CITY OF NEW YORK
DEPARTMENT OF ENVIRONMENTAL PROTECTION
BUREAU OF ENGINEERING DESIGN & CONSTRUCTION
WM-30 WATERSHED IMPROVEMENTS
RECONSTRUCTION OF
CATSKILL WATERSHED DAMS AND ASSOCIATED FACILITIES

GILBOA DAM AND ASSOCIATED FACILITIES RECONSTRUCTION
CONTRACT CAT-212B
ARCHITECTURAL

90% SUBMITTAL

EAST OVERLOOK PARTIAL PLAN - SHEET 1 OF 2

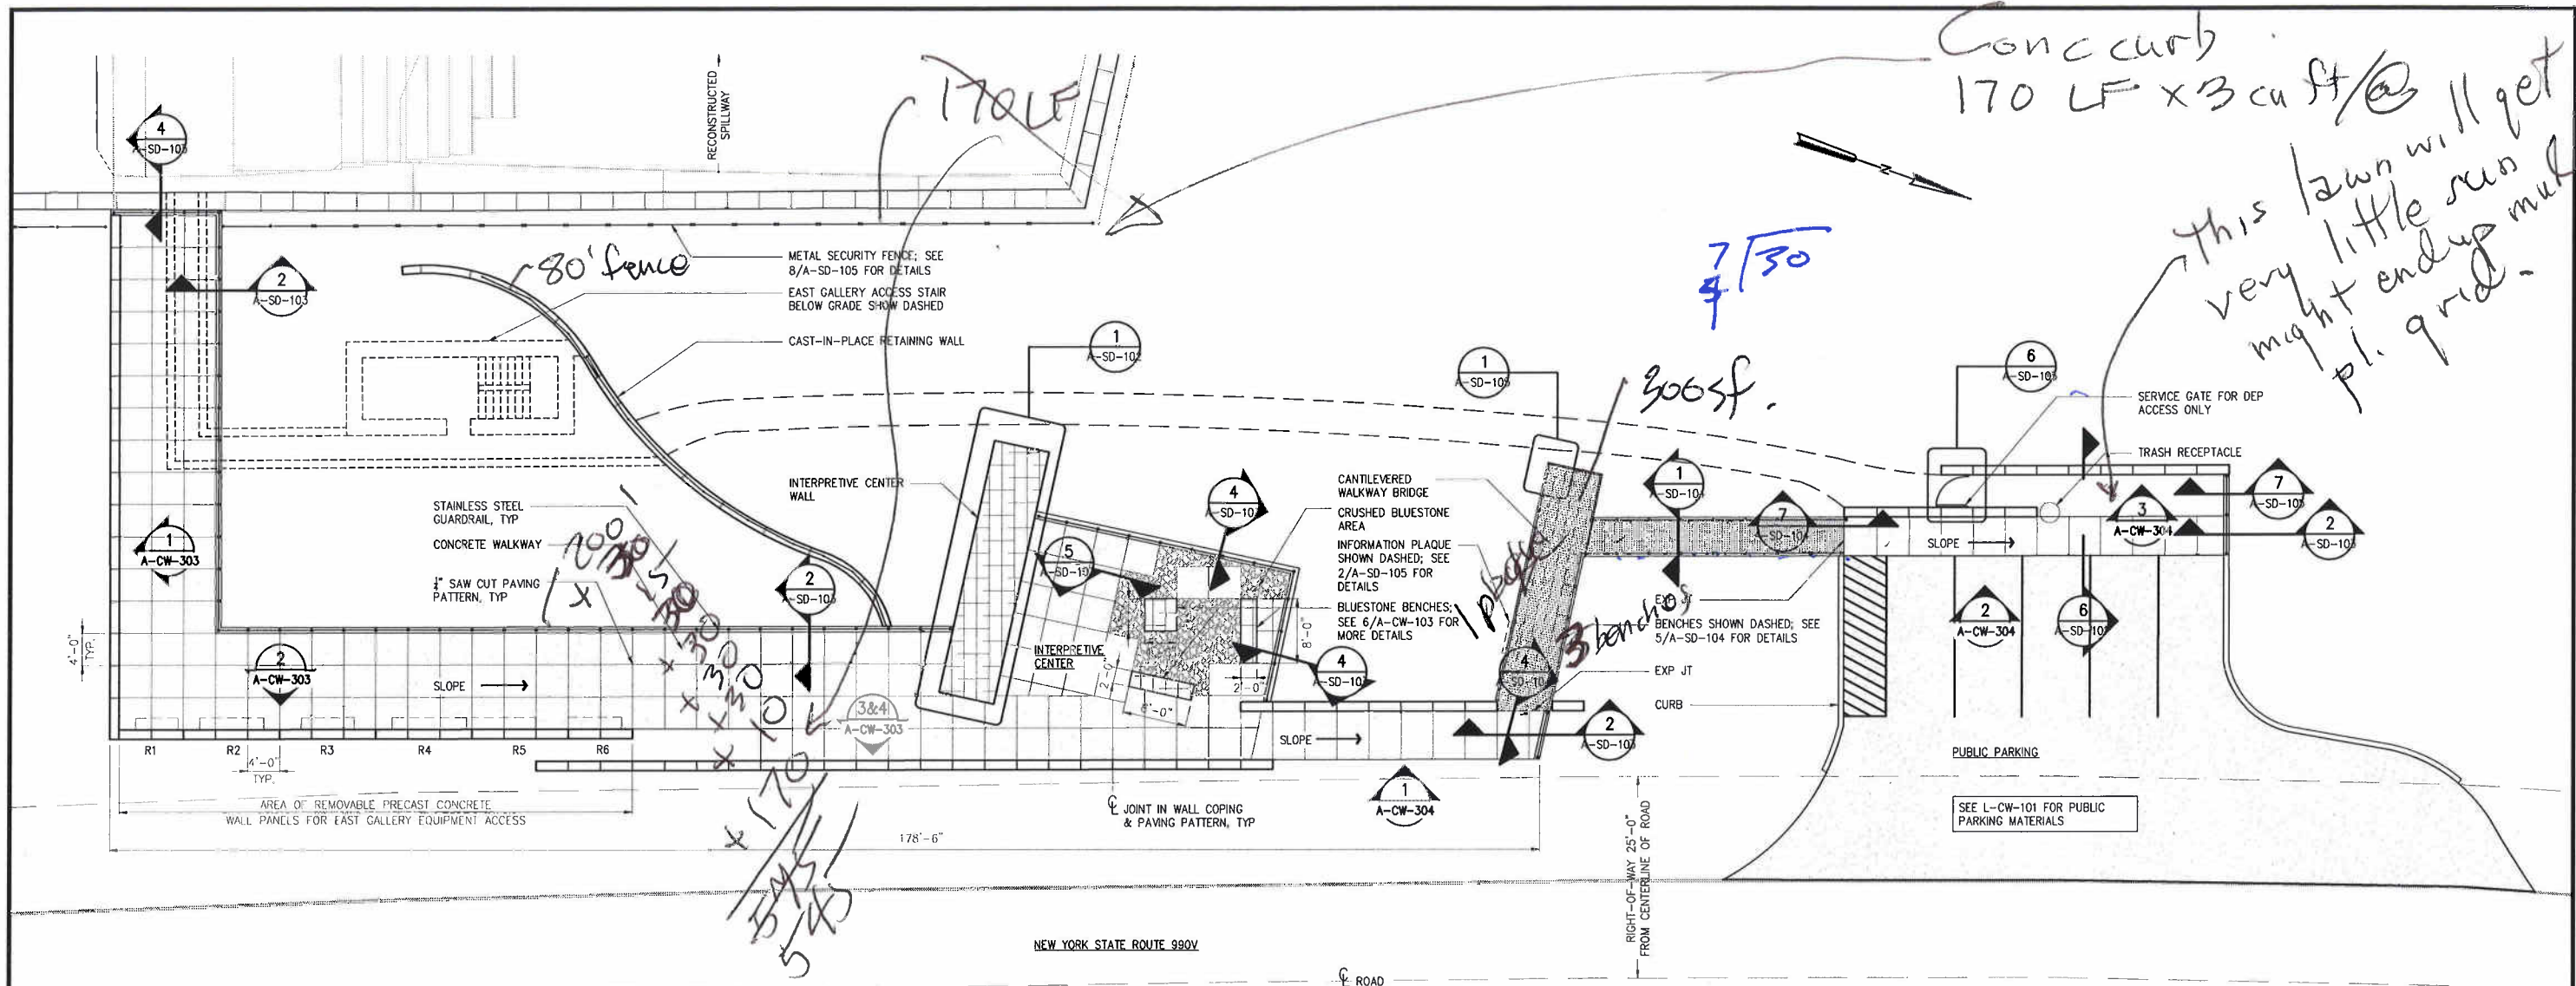
Not Inc: Footings, Concrete walls, excavation, gravel & other fill, back filling, grading & landscaping
Concrete cantilevered benches
Site paving

If truck/crane has to roll this way will paving take load & stabilize?

① 2025 2009 #
② 470 Paving
③ Copying Pins 470 to 638
1330' ÷ 4 x 2 ex end
Blue stone

④ 1040 sq. cmu brick "8x16"

⑤ (4 ea) Slugged Restore Hist. Wall Plaques
± 3' x 2'

⑥ Lifting points eye bolts 4 per panel
24 total

⑦ ss. cap at lifting points assumed continuous 65' x 8" x 1/8" ss plate
in 3 pcs w/ 2 welds.
Grout 1/4" bead 130 LF

⑧ Trash receptacle (1)

⑨ 1050 # 18" DEEP BLUESTONE - 4 250 anchors
⑩ ss. cap flashing 32' ± 6" 10 ga ss w/ 4 bends
+ 64 LF 1/4" bead of caulk
⑪ 9 ss rollers App 18" High ea set on pins

⑫ App 4 cu yd crushed bluestone
⑬ 64 cu ft of bluestone for benches
App 88 sf of App 18" deep bluestone
Doweled
App 175 ss pins mortared in place

DETAILS 1 OF 5

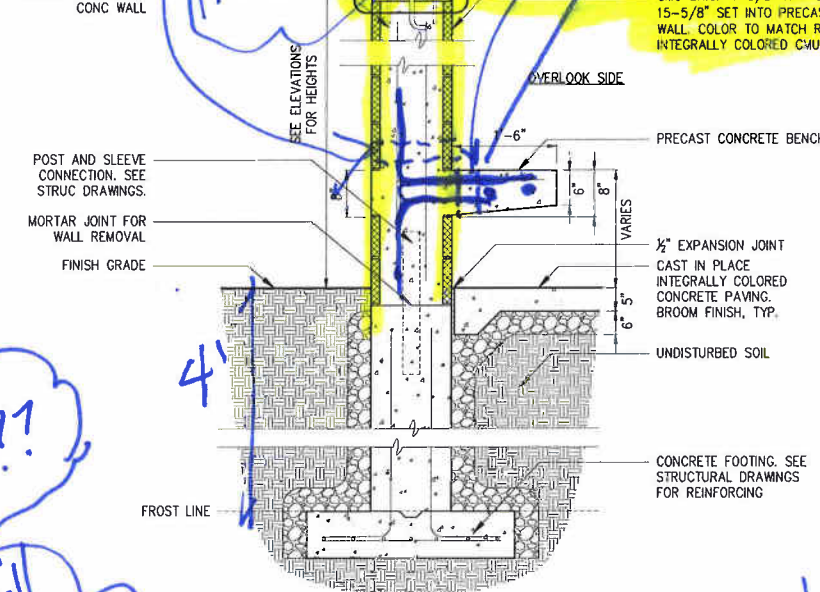
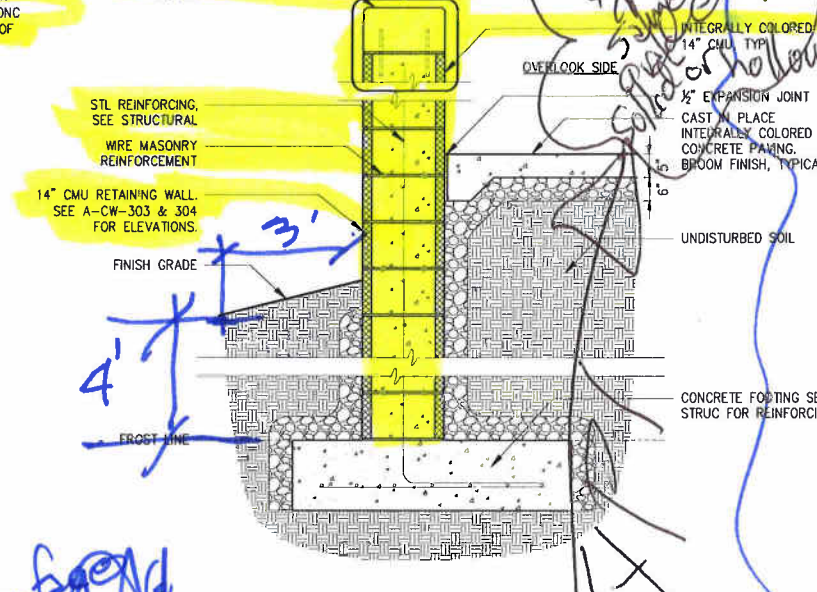
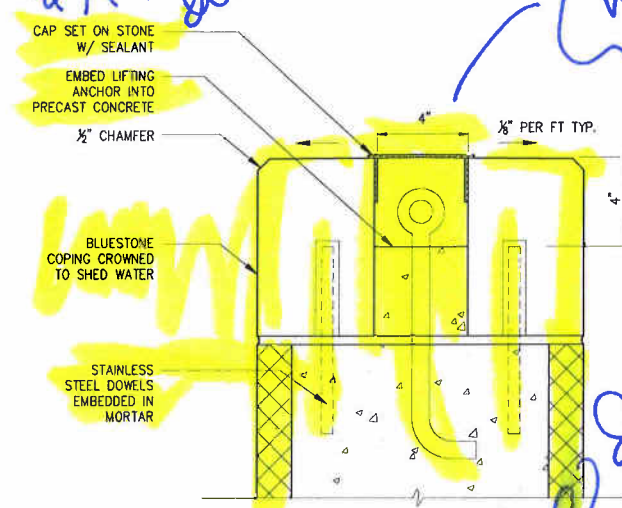
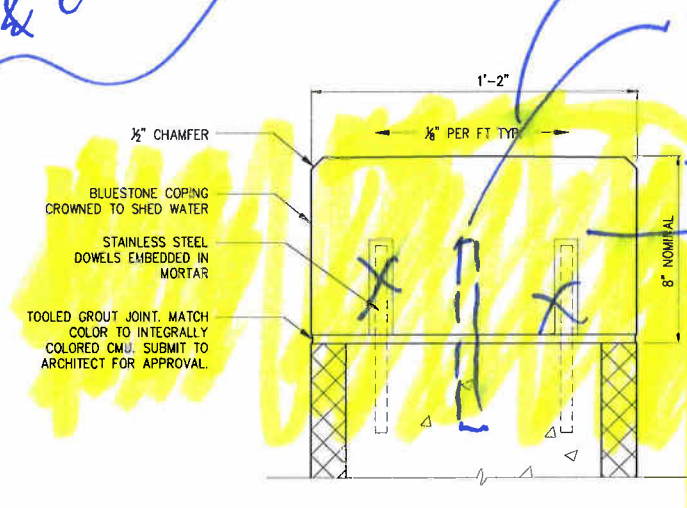
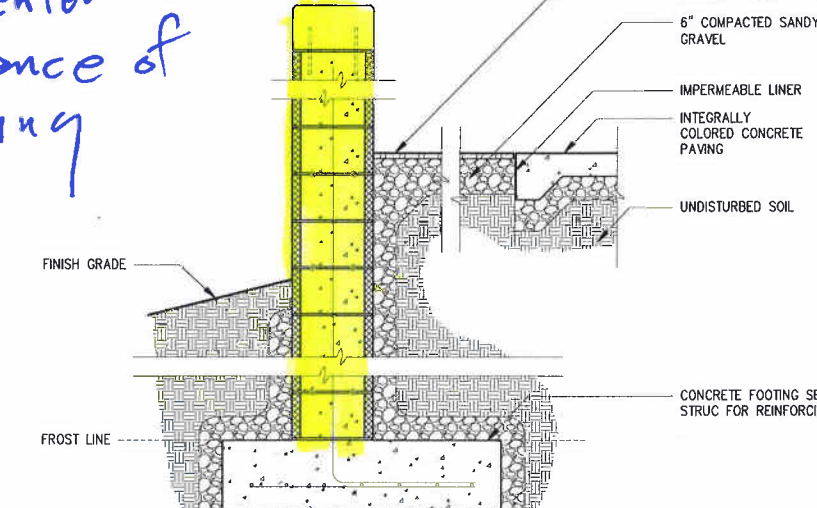
*spacing double leads
drains for built
up water level
snow will create
ice dam at edge
creating a "pond"
double as
lifting point.
Cheaper to
might cast in place
SS tube lining
if you like the look
its an off center
lift no matter
where the lifting
points are*

*heavy rebar 12" oc
2" holes 4" oc 4 per bench equal*

*or more
wherever
frost line is
see
also
get 2, 3, 4*

*Drain to fill
daylight??
It's going to fill
with water &
freeze & crack*

*slope to outer face
to water & away from wall
one in center
less chance of
cracking
4" min*

GILBOA DAM AND ASSOCIATED FACILITIES RECONSTRUCTION
CONTRACT CAT-212B
ARCHITECTURAL
DAM RECONSTRUCTION
DETAILS - SHEET 2 OF 5

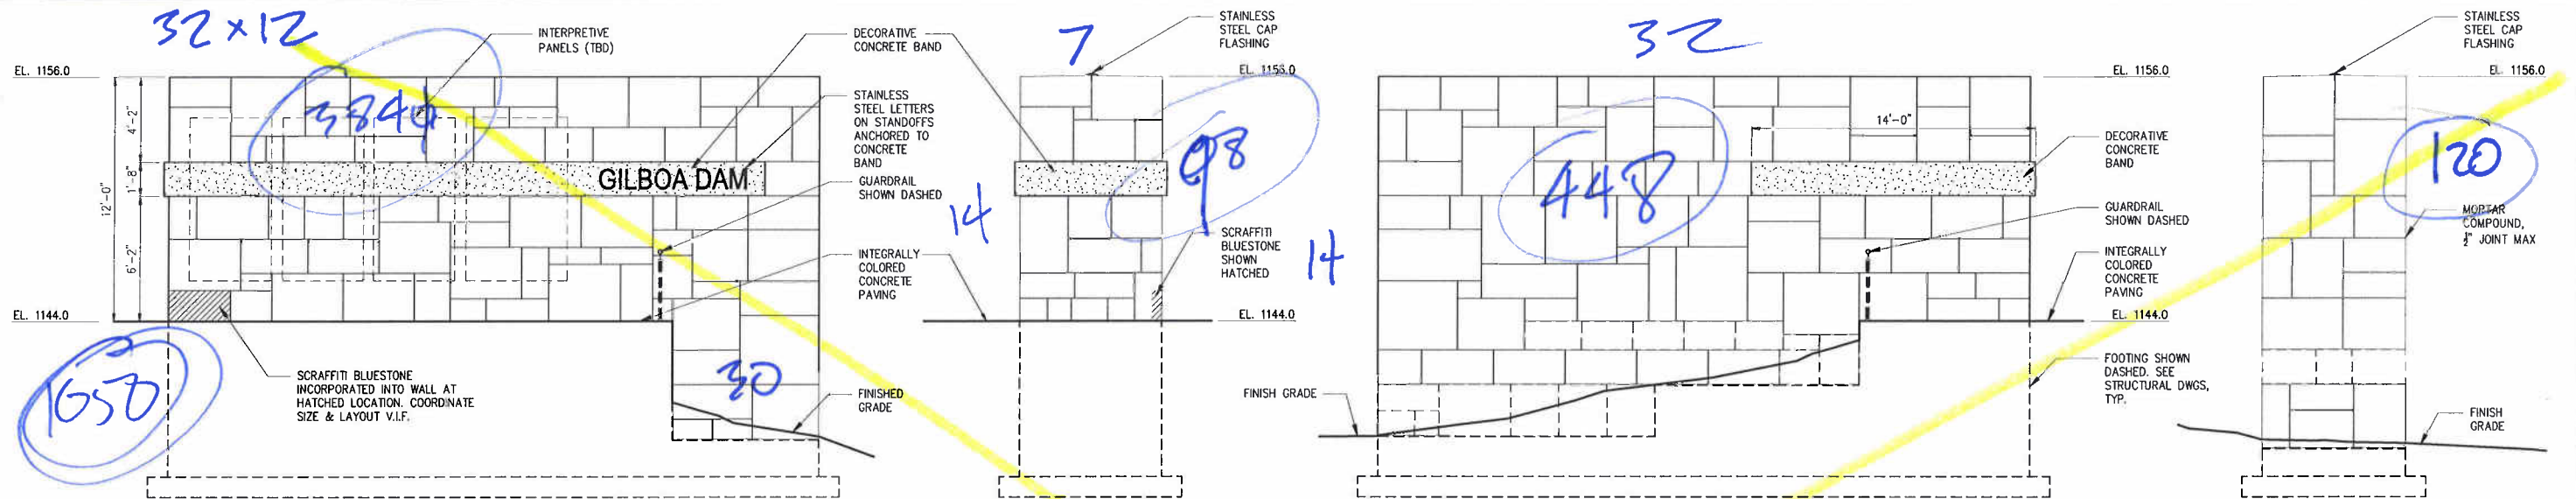
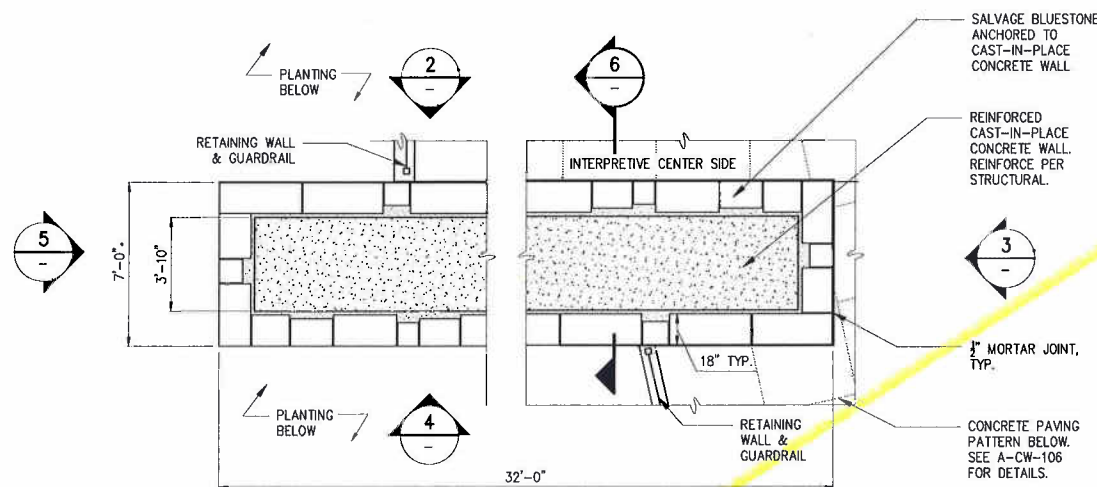
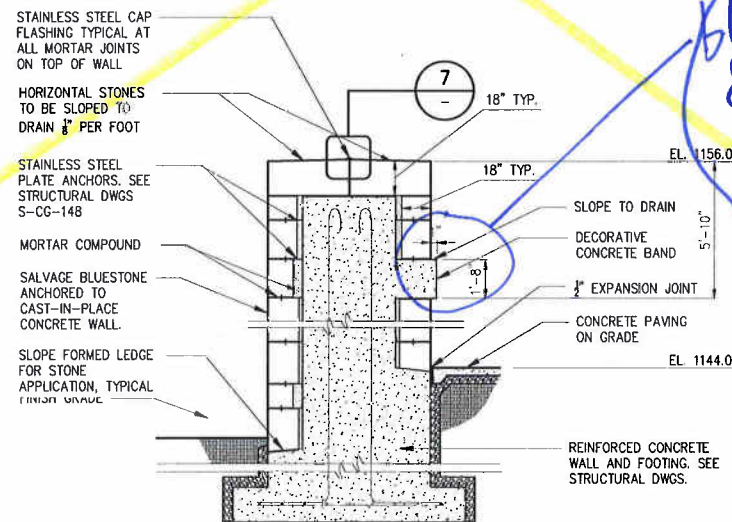
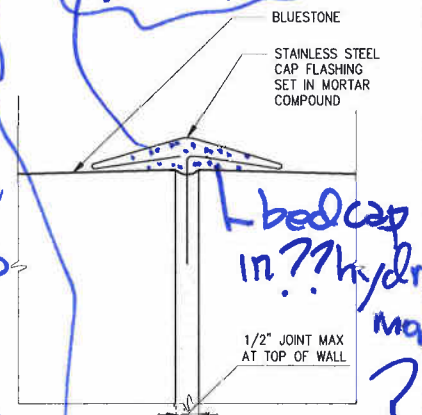
*blow up hard to read
if you want chambers
on corners. If you
want a fine finish
you'll need to spec it
& refer to it here
fine finish in offset
on a big pour like
this. might want to
cost separately?*

GILBOA DAM AND ASSOCIATED FACILITIES RECONSTRUCTION
CONTRACT CAT-212B
ARCHITECTURAL
DAM RECONSTRUCTION
DETAILS - SHEET 3 OF 5

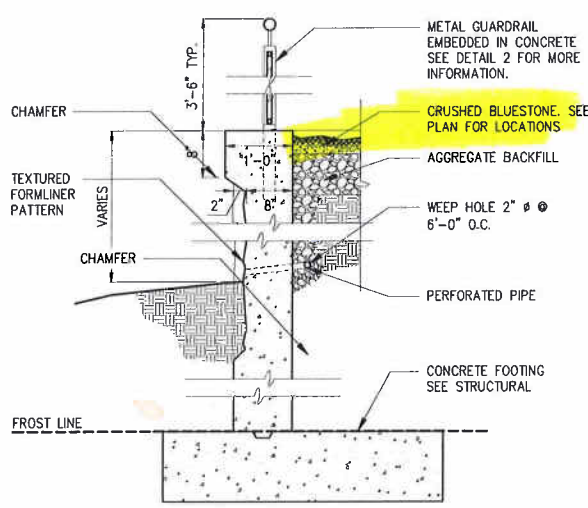
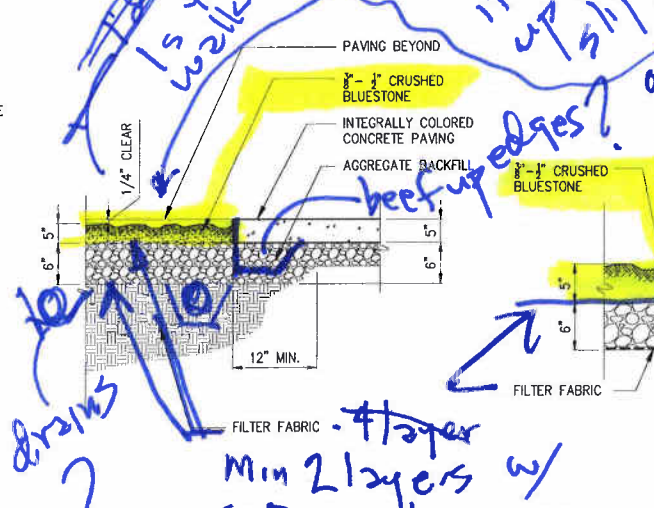
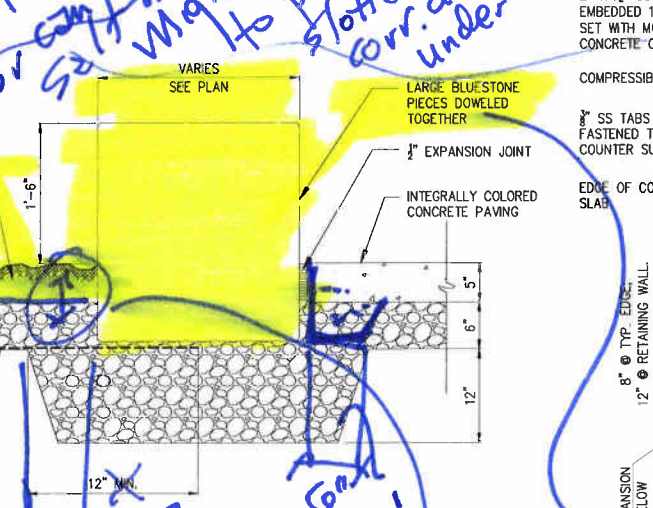
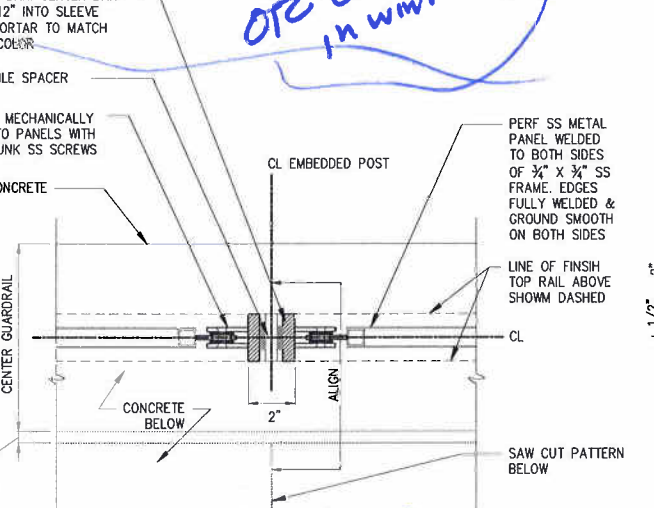
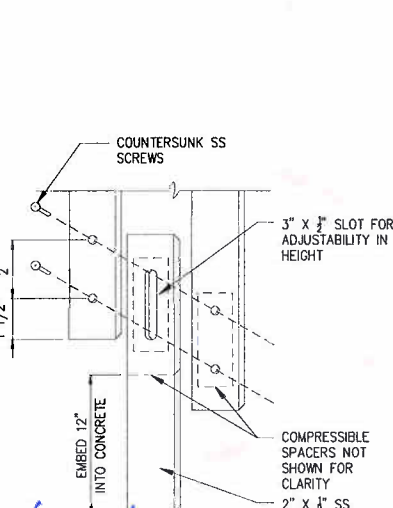
Is the idea you? walk on gravel? its going to heave up in winter builds up water becomes slipping hazard or can't walk heavily? Might want to put some slotted corr. drains under this & drain to daylight (where salt runoff will be ok) or closes in winter?

beef up edges? or can't walk heavily? Might want to put some slotted corr. drains under this & drain to daylight (where salt runoff will be ok) or closes in winter?

drains? Min 2 layers w/ 50% overlap on seams

you'll get mixing in winters at least w/ fabric separation

You need more than dowels to keep rocks from spreading
